ADDENDUM NO. 1

CIP NO. 2025-01 – NEW AMPHITHEATER ROOF, RECLADDING, AND DRAINAGE IMPROVEMENTS

June 23, 2025

1. ADDENDUM NARRATIVE FOR REMOVED ELECTRICAL SCOPE:

E-002

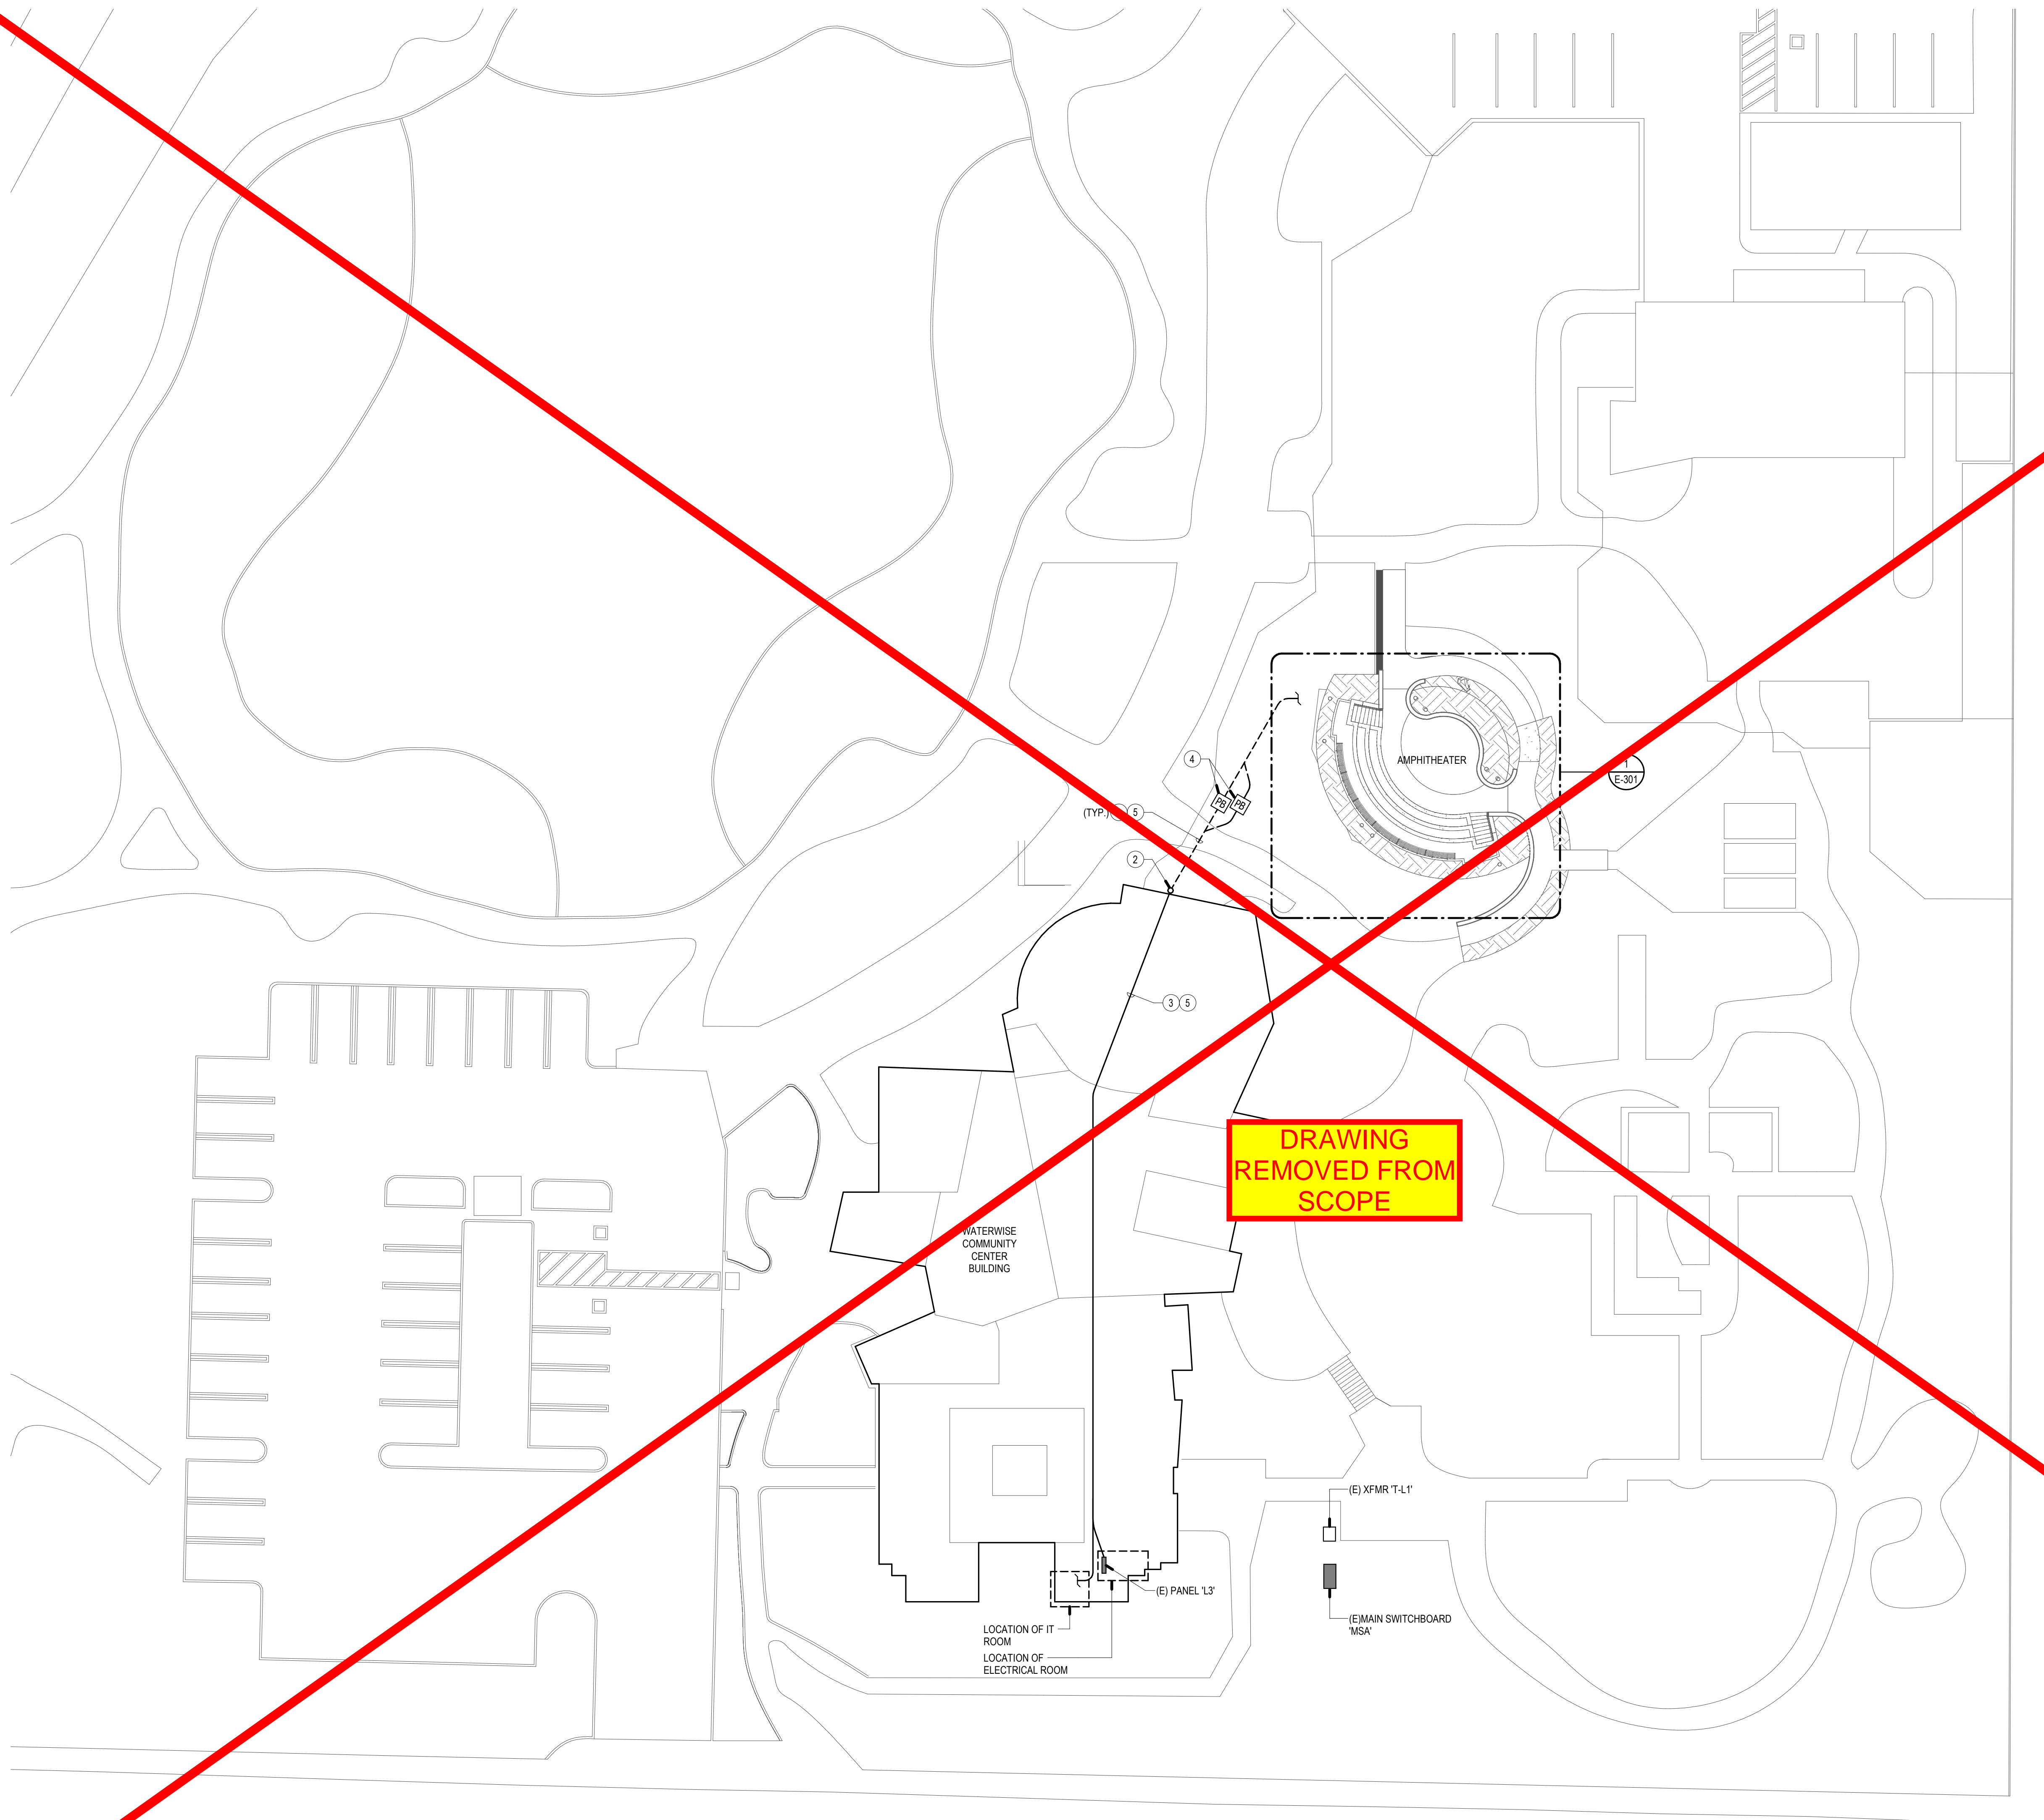
- Sheet E-002 – Deleted in its entirety
- Sheet E-101 – Deleted in its entirety
- Sheet E-301 – Deleted in its entirety
- Sheet E-401 – Deleted in its entirety
- Sheet E-501 – Deleted in its entirety

E-301

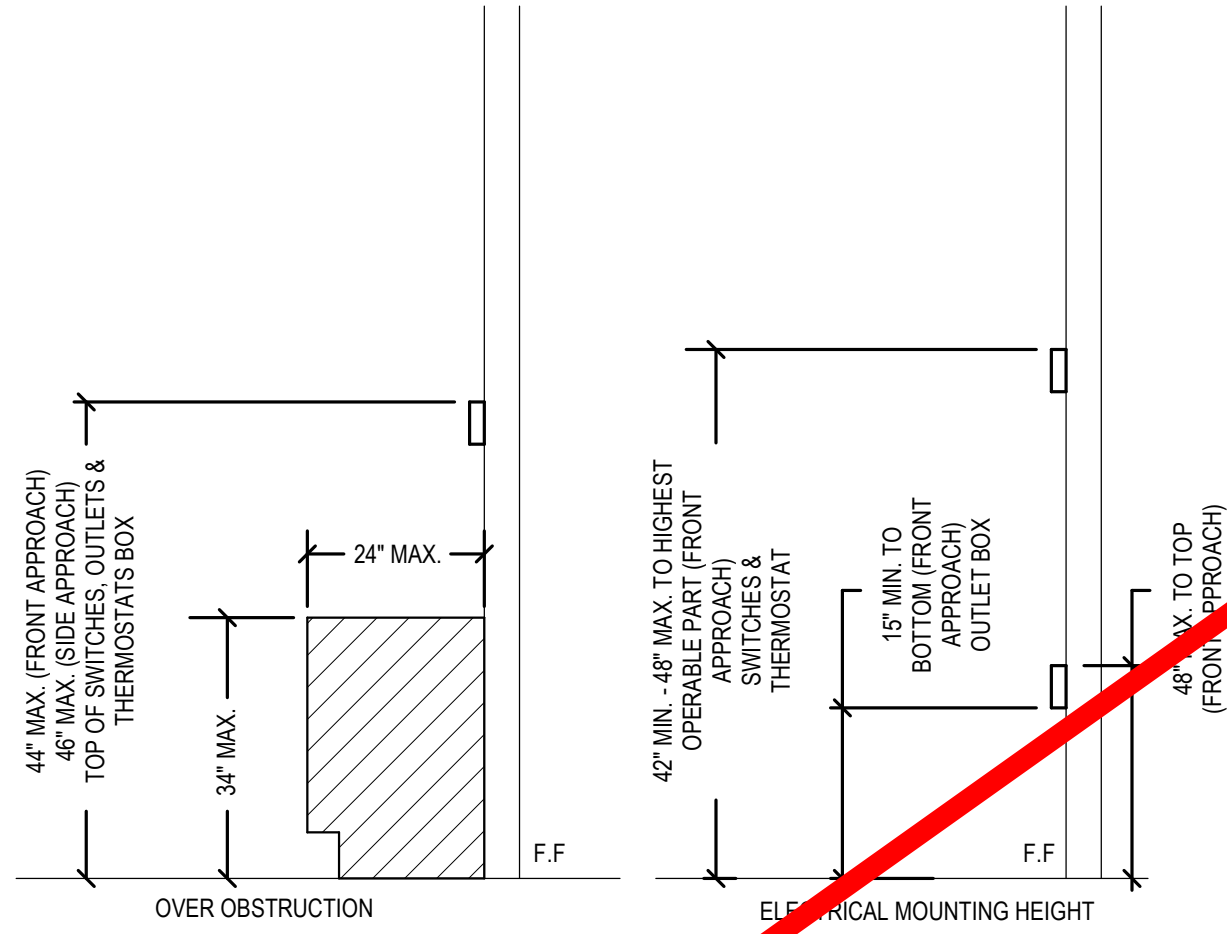
DRAWING
REMOVED FROM
SCOPE
